MIAMI BEACH

Staff Report & Recommendation

Design Review Board

SUBJECT: DRB21-0738
291 Palm Avenue

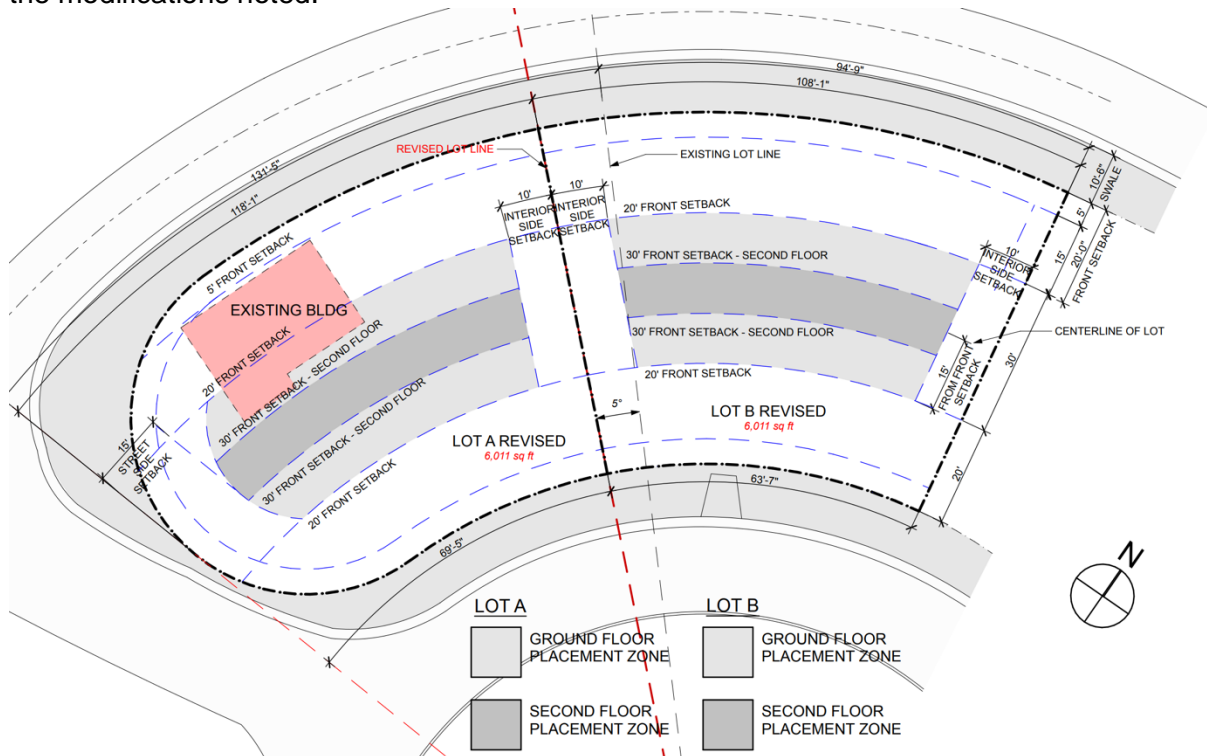
Regarding **Variance #8**, which is for balcony projections of 7 feet facing Palm Avenue, where the maximum is 4'-6", staff believes this request is excessive, and results in a domineering street presence, especially in light of the reduced setback proposed for the main home. Staff recommends that the variance only be approved for the first habitable floor, and that the second-floor balcony, as well as the roof top overhang, comply with the maximum projection otherwise allowed. Additionally, staff recommends that the design of the expansive balconies that face Palm Avenue, as shown in the rendering below, be broken up in an effort to provide more interest along the façade, as well as to minimize the two-story elevation's impact on the street.

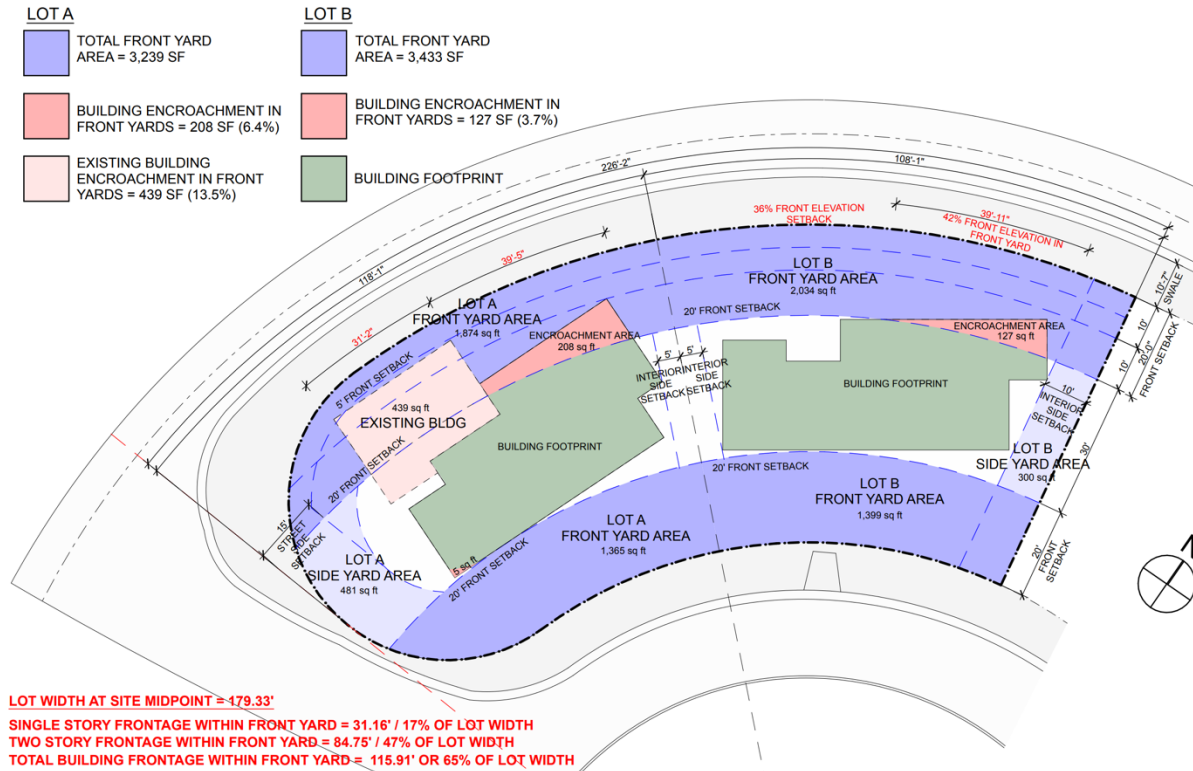
The diagram below, from Sheet A-016 of the application, highlights the proposed building footprints for each lot, and the area highlighted in salmon color indicates the portion of the home that encroaches into the required 20 foot front yard. However, it also must be noted that the required setback is actually 30 feet, as the structure is 2-stories, but the purpose of this diagram is to show that only portions of the home encroach into a 20 foot front yard along North Coconut Lane.

Staff would also point out that the existing 2-story home (although much lower in height than the proposed new home) has a setback of around 5 feet for a large frontage of the home along North Coconut Lane. Again, based upon the hardship presented by the unique shape and depth of the lot, staff is supportive of the requested variances related to the primary setbacks of the home (**Variances #4 & #5**), including the proposed interior side setback (**Variance #6**) which maintains the minimum required setback from the street side yard.

The variance diagrams below, from Sheets A-013A and Sheets A-014A, outlines the majority of the requested variances:

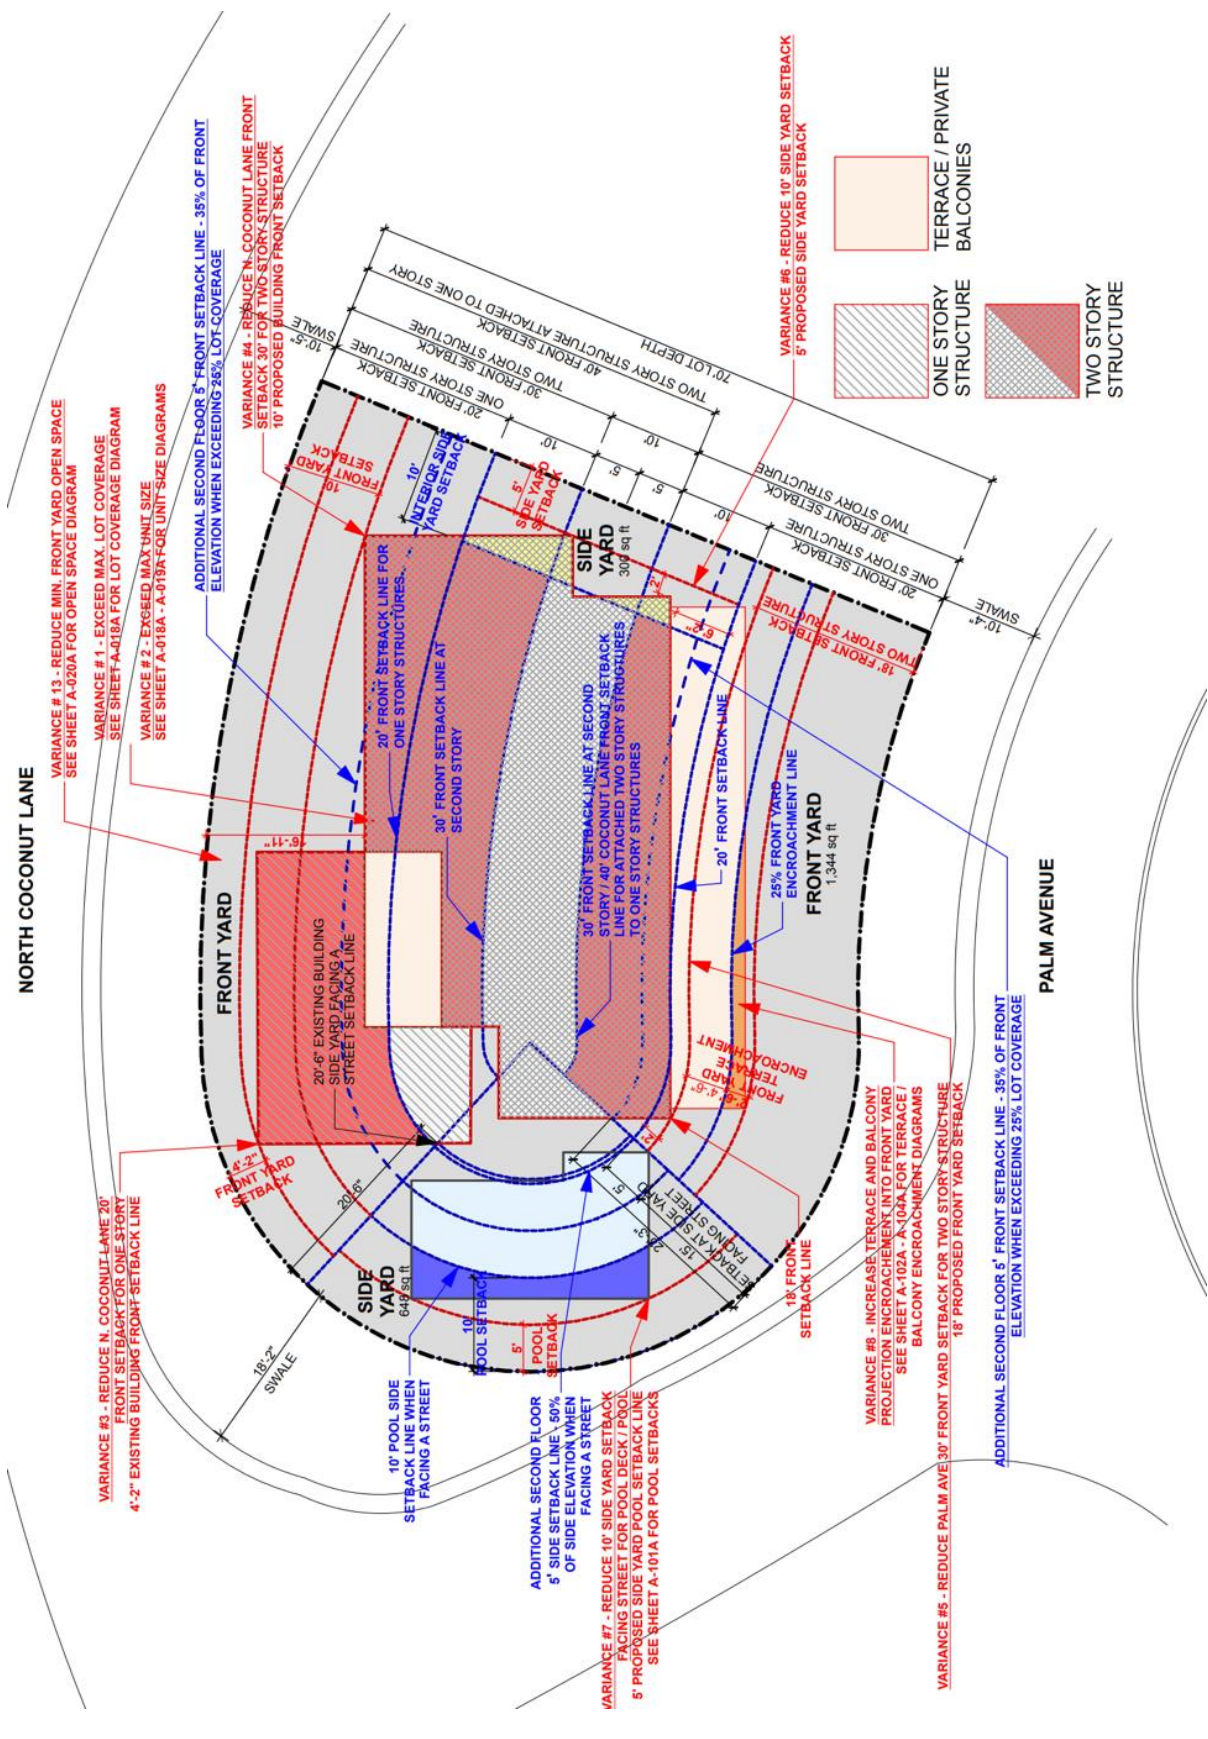
Due to the unique configuration of the lot, shallow lot depth, frontage on 2-sides, and a street facing side, the placement of a pool on the site also presents a practical difficulty for its construction. For these reasons, staff is supportive of **Variance # 7**.

Due to the minimal depth of the home, as well as the shape and depth of the lot, both of which presents practical difficulties with designing a code compliant roof deck, staff is supportive of the requested setback variances for the roof deck (**Variance #9**).

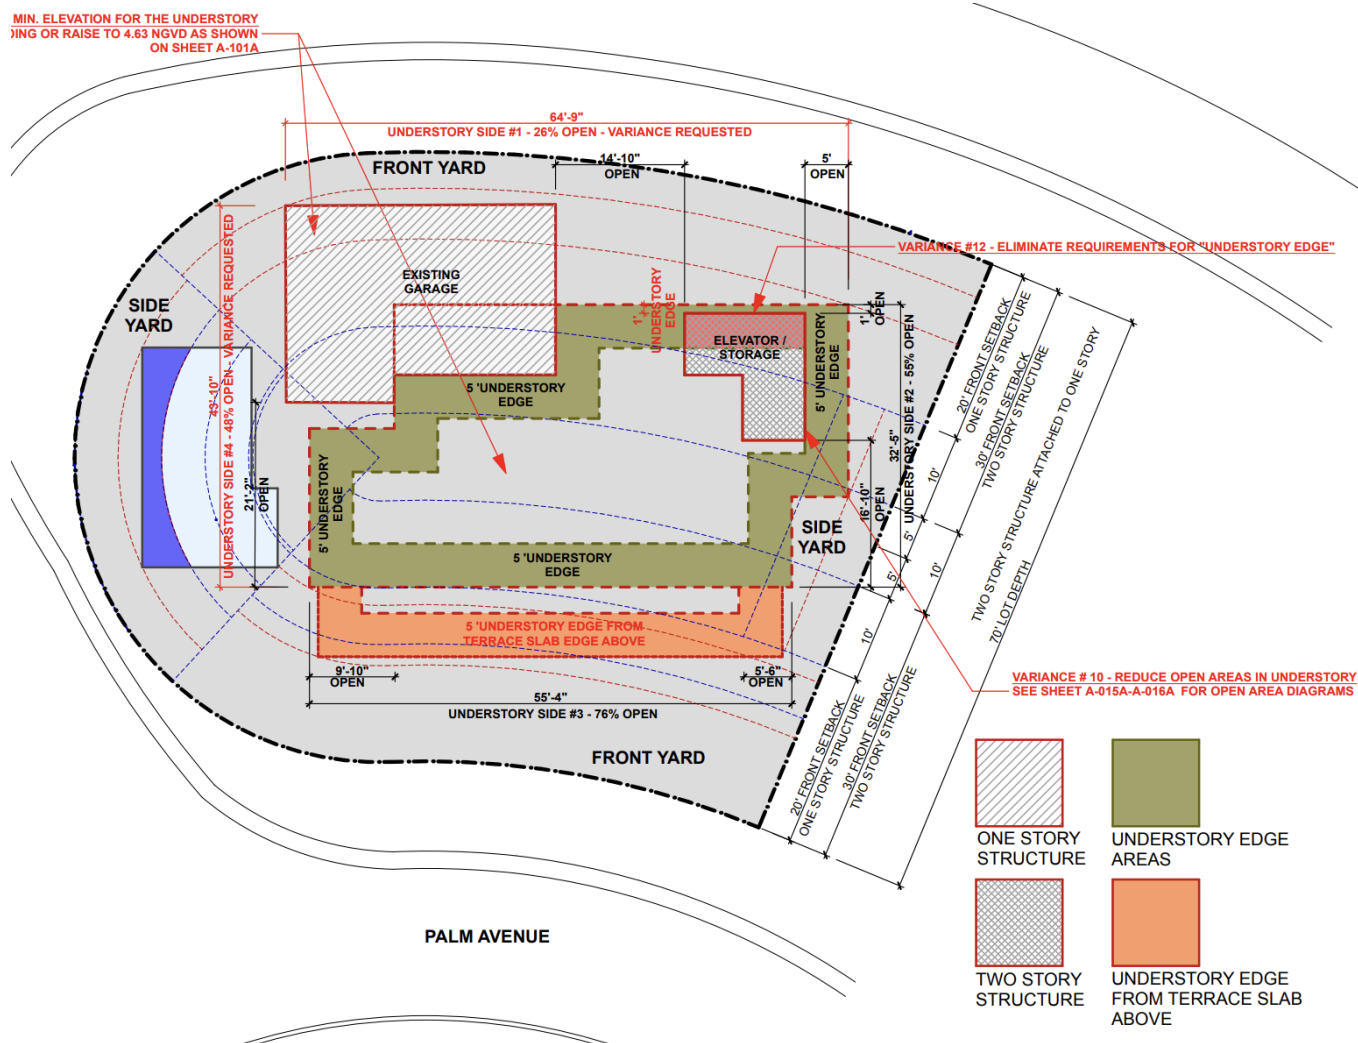
Variances 10-13 are all related to the understory requirements, as outlined in the below diagram from sheets A-014A from the application. Due to the hardship presented by the site, and practical difficulties previously noted, staff is supportive of these variances, as requested.
